SUBJECT: THREE MILE ISLAND NUCLEAR STATION, UNIT 1 - ISSUANCE OF  
AMENDMENT RE: REVISION TO THE PRESSURE AND TEMPERATURE  
LIMIT CURVES AND THE LOW TEMPERATURE OVERPRESSURE  
PROTECTION LIMITS (TAC NO. MF0424)

Amendment No. 281  
Renewed License No. DPR-50

REVISION TO THE PRESSURE AND TEMPERATURE LIMIT CURVES

THREE MILE ISLAND NUCLEAR STATION, UNIT 1

### Figure 3.1-1 Reactor Coolant System Heatup and Criticality Limitations [Applicable through 50.2 EFPY]

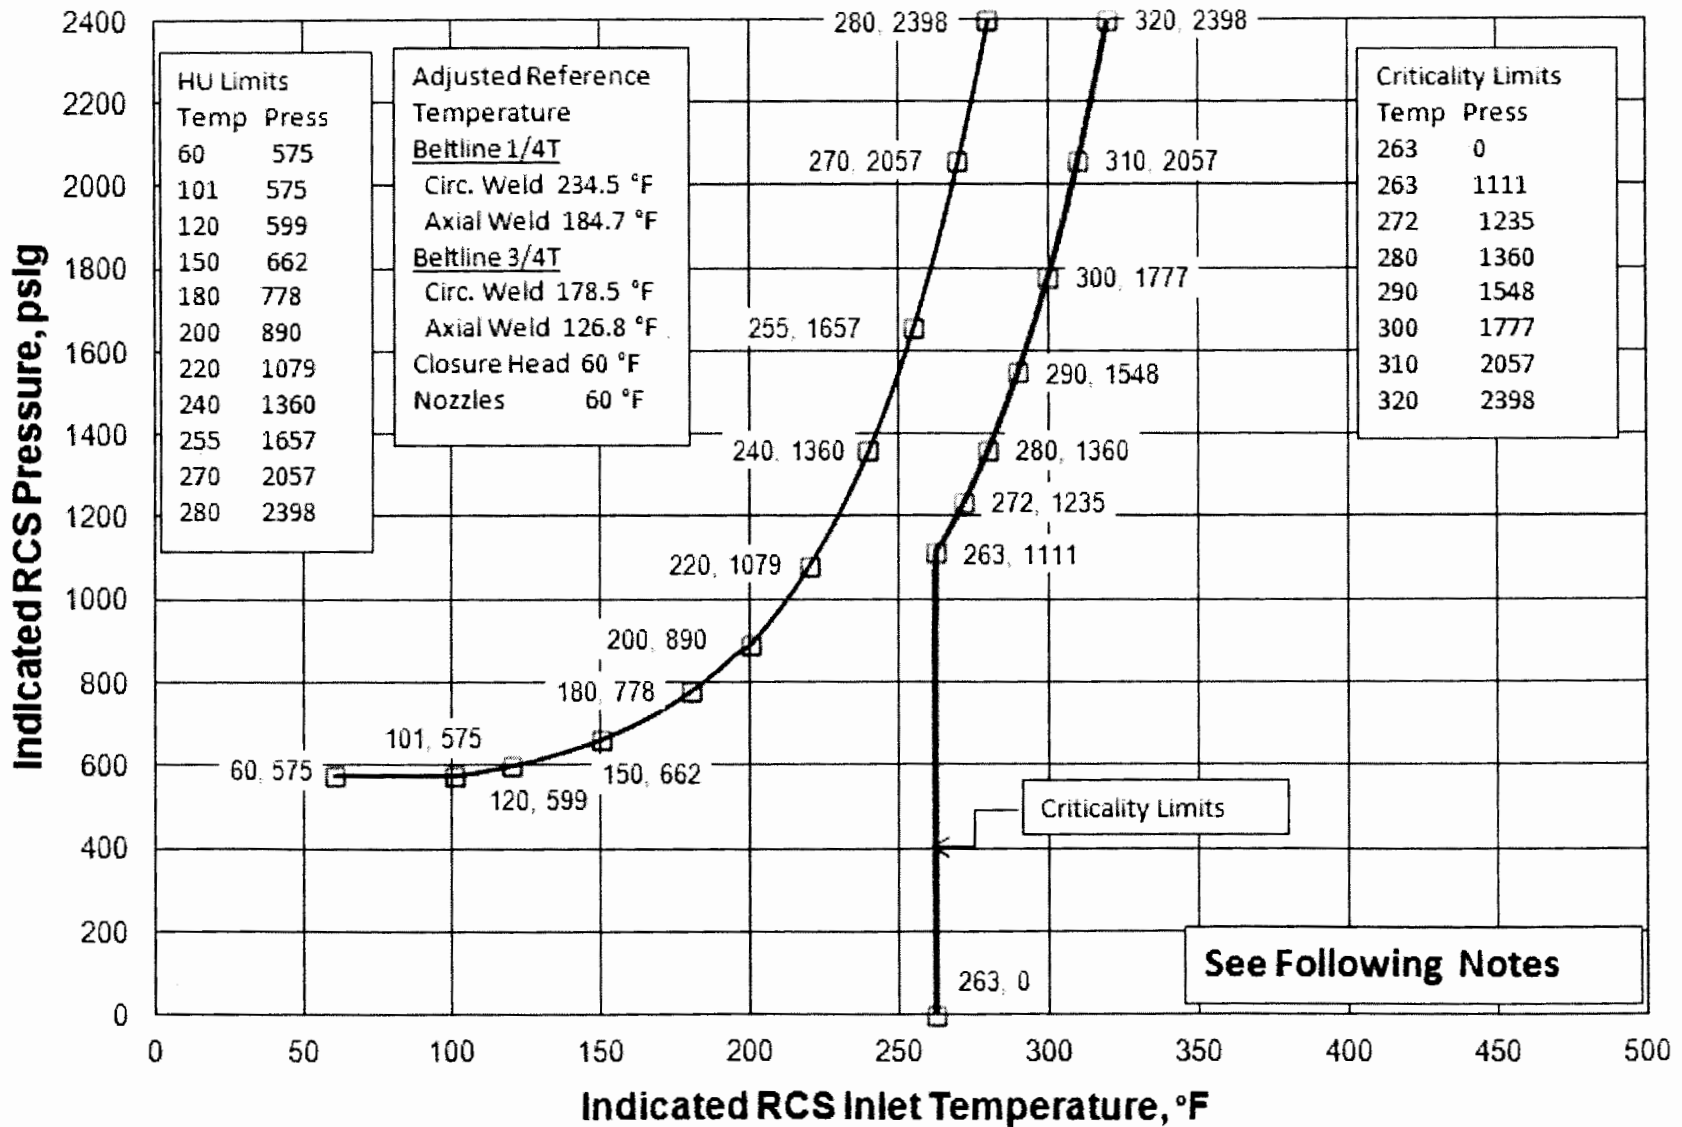
The amendment revises the TMI-1 technical specifications with new pressure-temperature (P-T) limit curves and low-temperature overpressure protection system requirements. The P-T limit curves were revised to provide new curves that are valid to 50.2 effective full-power years for TMI-1.

Based on the predicted  $RT_{NDT}$  after 50.2 effective full power years of operation, the pressure/temperature limits of Figures 3.1-1, 3.1-2, and 3.1-3 have been established by AREVA calculation, Reference No. 8, in accordance with the requirements of 10 CFR 50, Appendix G. The methods and criteria employed to establish the operating pressure and temperature limits are as described in BAW-10046A, Rev. 2 and ASME Code Section XI, Appendix G, as modified by ASME Code Case N-640 and N-588. The protection against nonductile failure is provided by maintaining the coolant pressure below the upper limits of these pressure/temperature limit curves. The minimum temperature for core criticality is determined to satisfy the regulatory requirements of 10 CFR Part 50, Appendix G. This limit is shown on Figure 3.1-1.

**Figure 3.1-2  
Reactor Coolant System Cooldown Limitations  
[Applicable through 50.2 EFPY]**

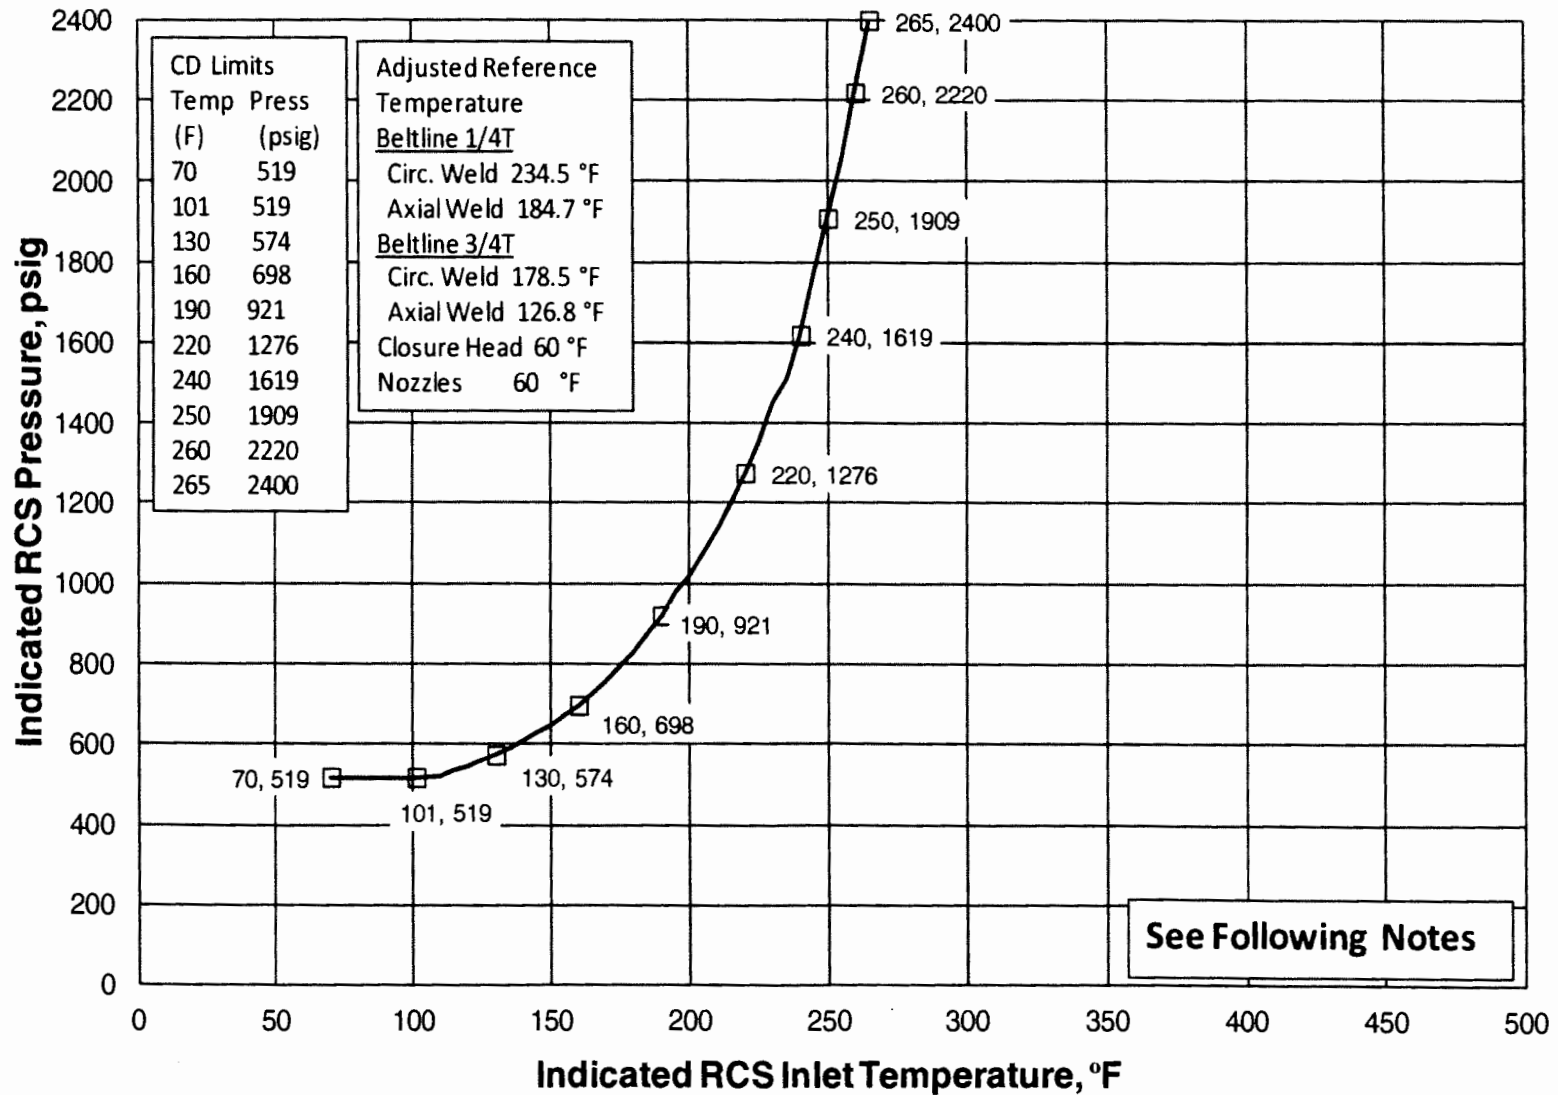
To assess the validity of the licensee's proposed curves, the NRC staff performed an independent assessment of the licensee's submittal. As part of the review, the NRC staff generated two requests for additional information (RAIs). First, the staff noted that in Section 4.6, "Reactor Coolant Temperature-Time Histories," of Attachment 4 to the original submittal dated December 14, 2012, the RPV coolant temperature-time histories used in the calculations of the proposed P-T limits are not consistent with Note 2 from Figure 3.1-2 in the proposed TS markup (Attachment 2 to the original submittal dated December 14, 2012). In RAI 1, the staff

asked the licensee to explain this discrepancy, or revise the submittal to make the text consistent.

In the response dated August 13, 2013, the licensee noted that the cooldown ramp history in Note 2 of Figure 3.1-2 in the proposed TS markup is correct. A revision to Section 4.6 of Attachment 4 was included to correct the typographical error. The NRC staff noted that the proposed revision is consistent with the rest of the document and finds the issue raised in RAI 1 resolved.

**Figure 3.1-3  
Reactor Coolant Inservice Leak Hydrostatic Test  
[Applicable through 50.2 EFPY]**

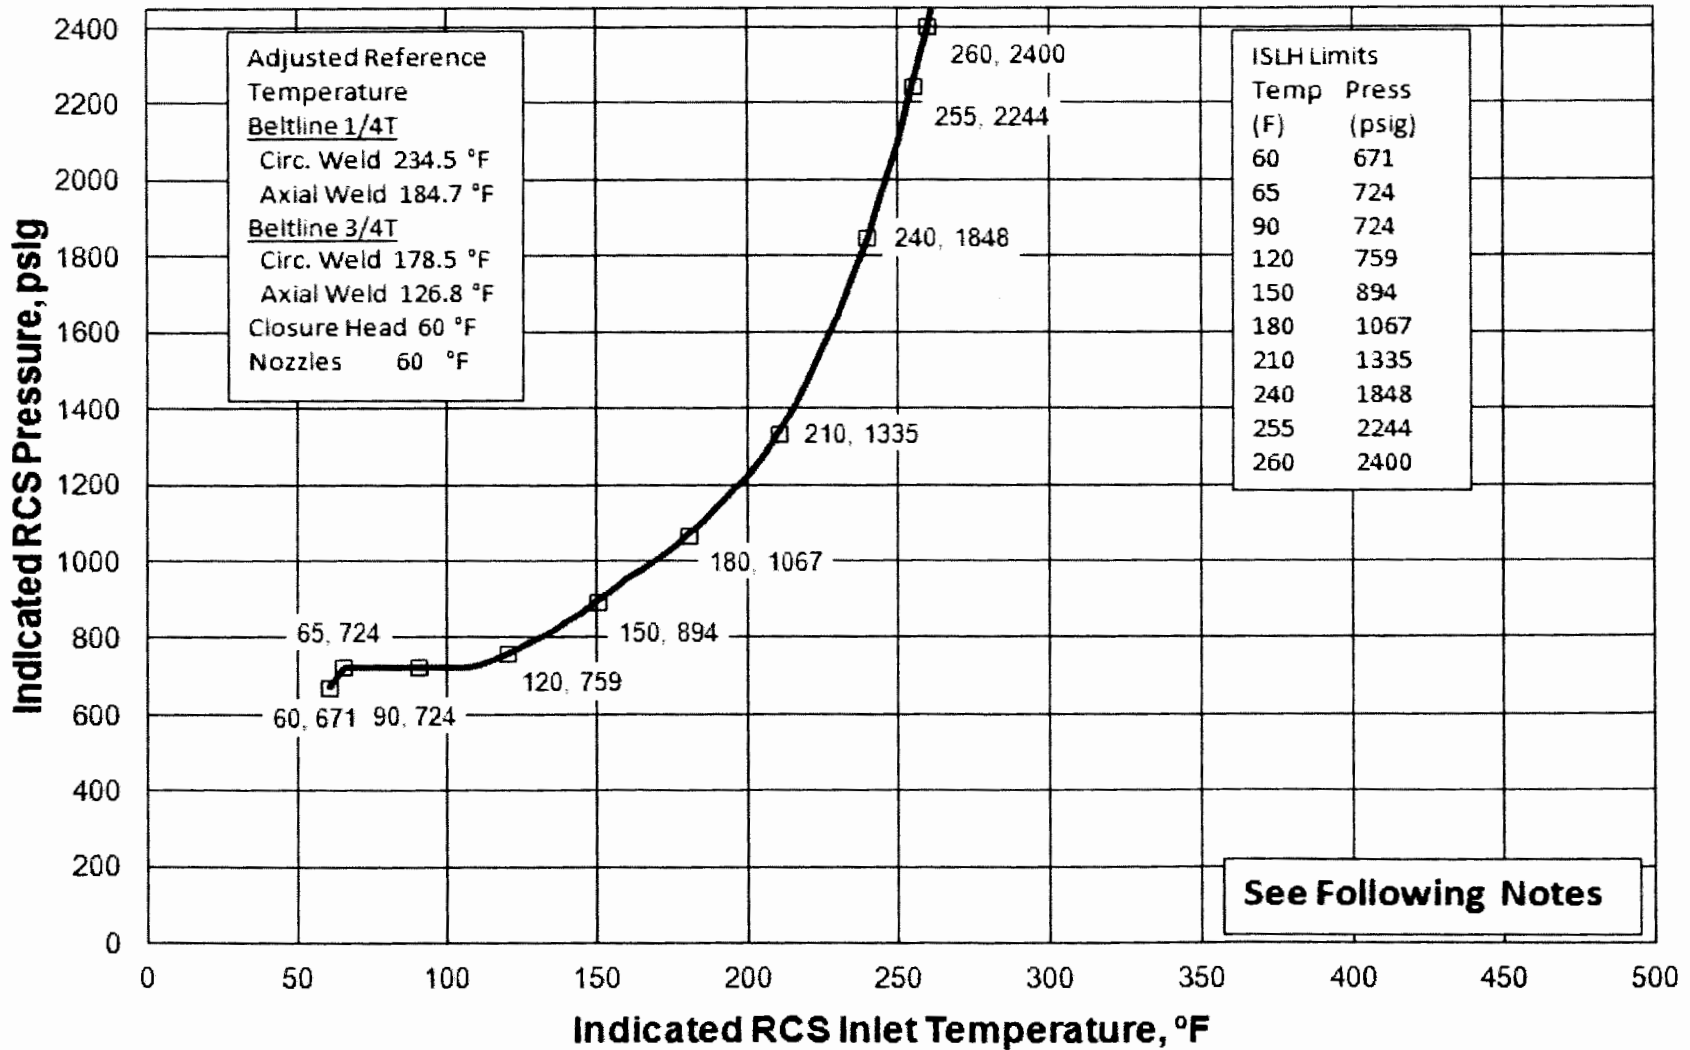
Allowable combinations of pressure and temperature shall be to the right of and below the limit line in Figure 3.1-3. Heatup and cooldown rates shall not exceed those shown on Figure 3.1-3.
